June 12, 2007

Re: **BZA2007-00029: An administrative adjustment to reduce the parking requirements for a community retail and restaurant use by 18% percent, from 123 spaces to 101 spaces.**

NORDYKE RETAIL
21st & TYLER

PROPOSED SITE PLAN

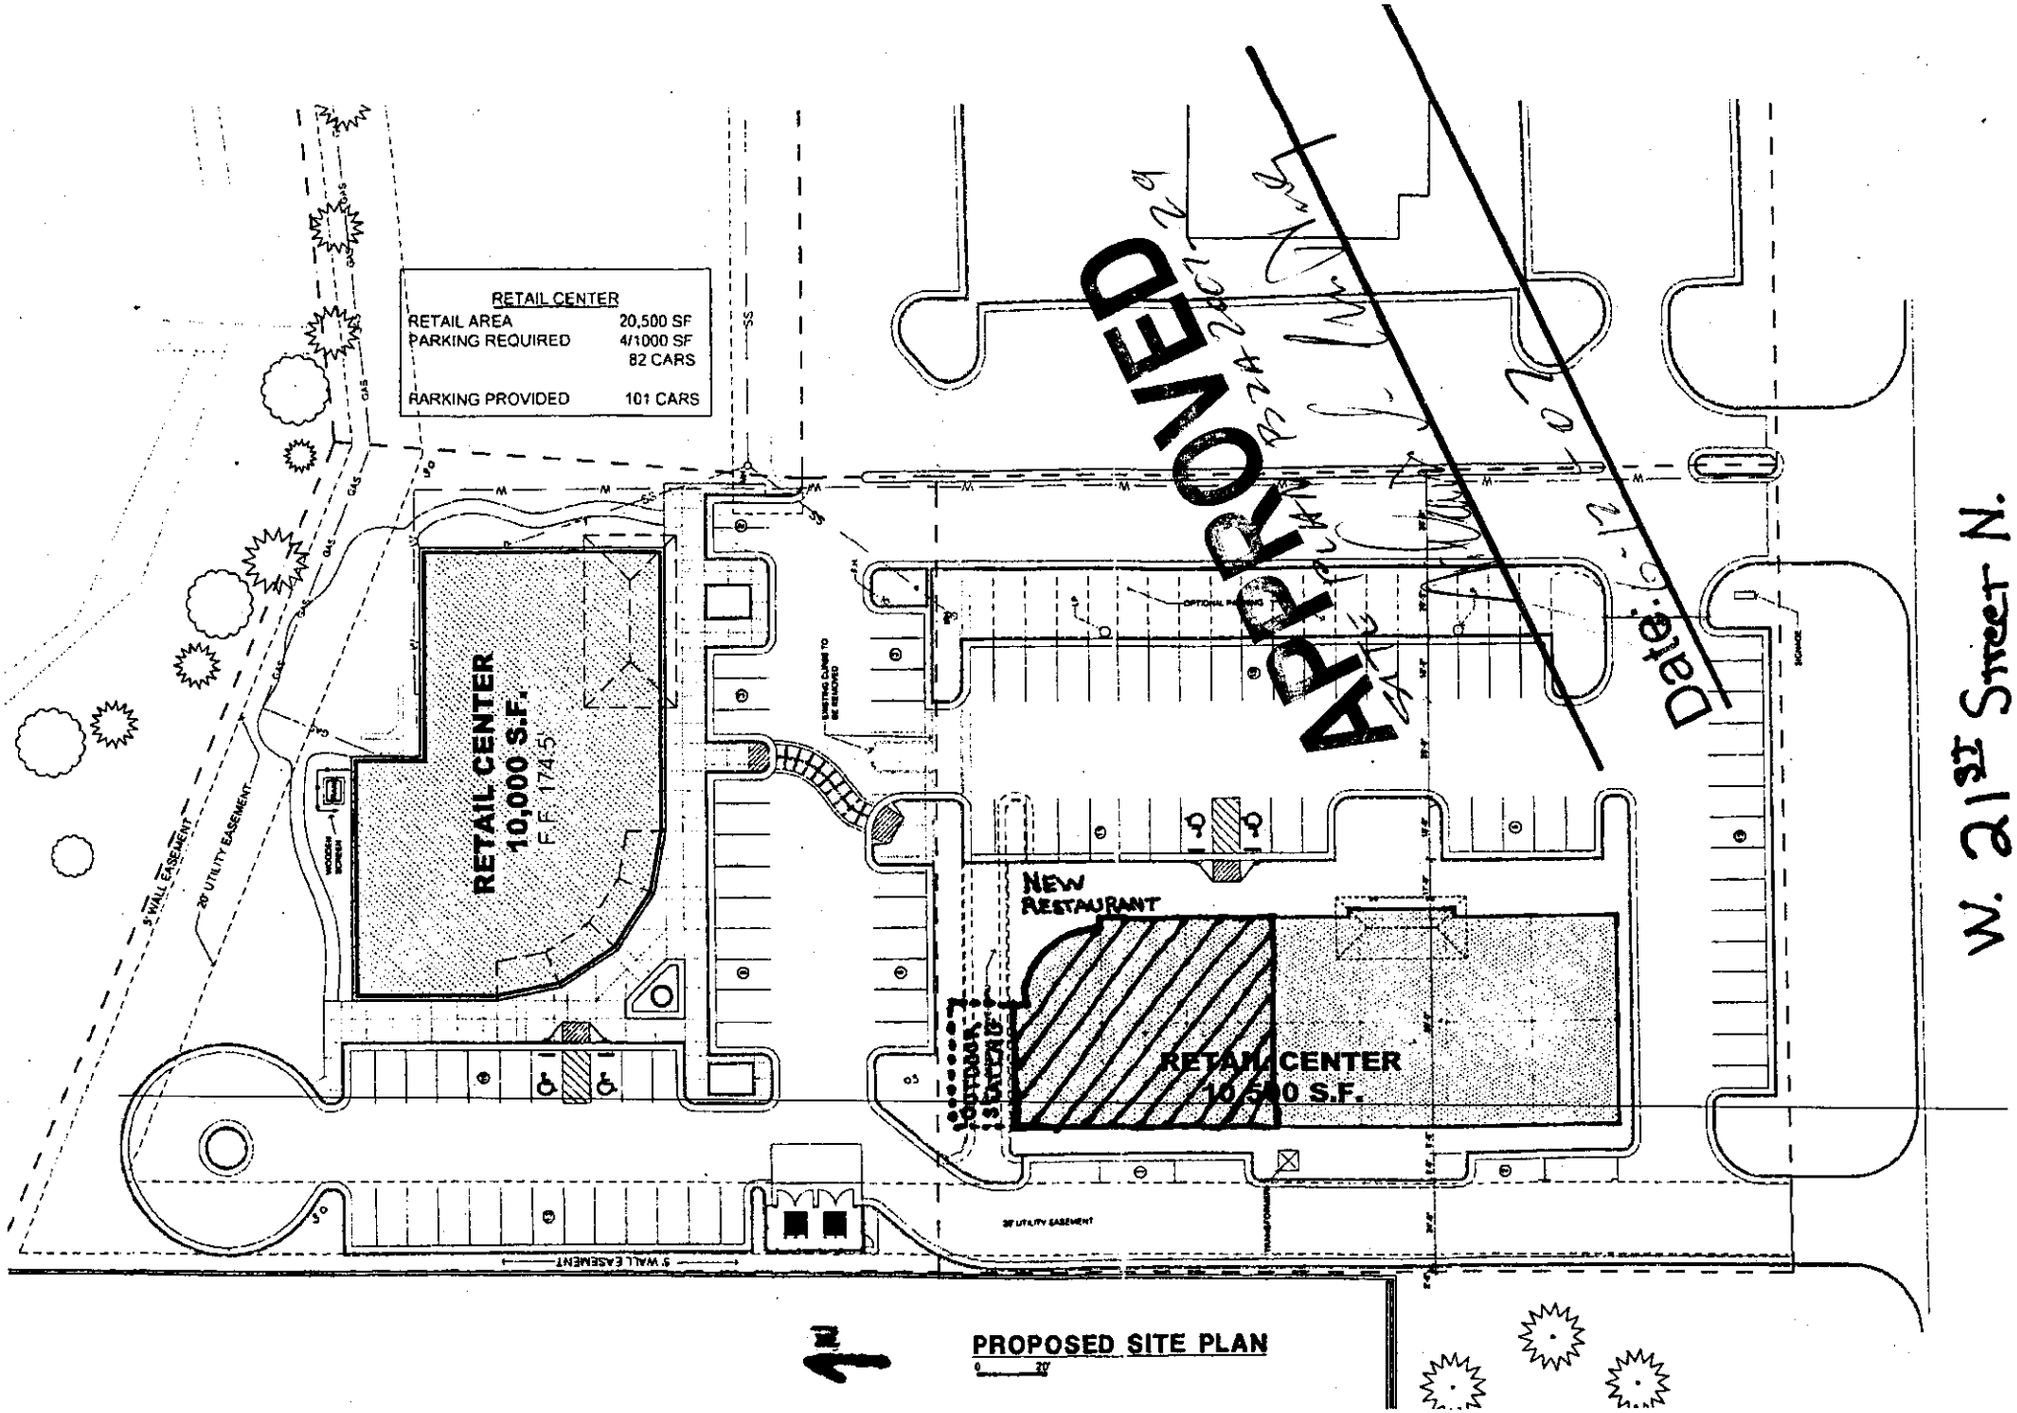
1) The site shall be developed in general conformance with the site plan submitted as part of this application.

2) All parking areas shall be paved and marked.
